Bikeway Design Charrette – design discussion paper

At ACC's Bikeways Design Charrette, attendees were asked to assess several typologies (basic layouts) for future bikeways – including suggesting any typologies not already covered. These boiled down to three configurations for a one-way bikeway on both sides of the street:

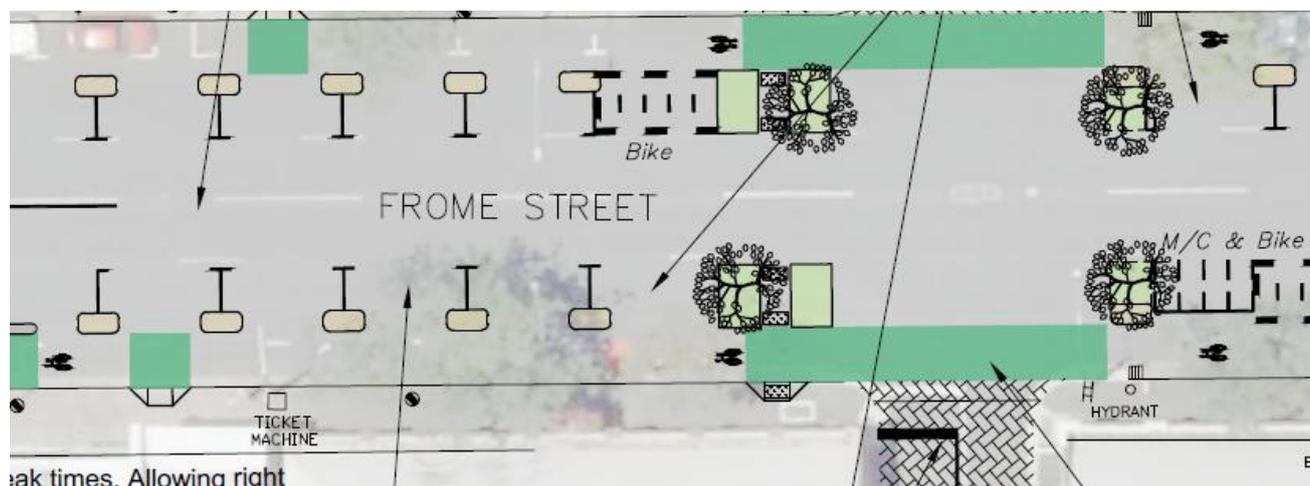
The existing Frome Bikeway falls into the first typology, more or less as shown in this image from the original design concept:

This concept showed a separator between the bike lane and parking, which widened out in some places (next to side streets) to accommodate trees. A complaint of those opposed to the existing Frome Bikeway is that this did not occur and the landscaping areas that were provided were not constructed to allow trees to be planted at a later date.
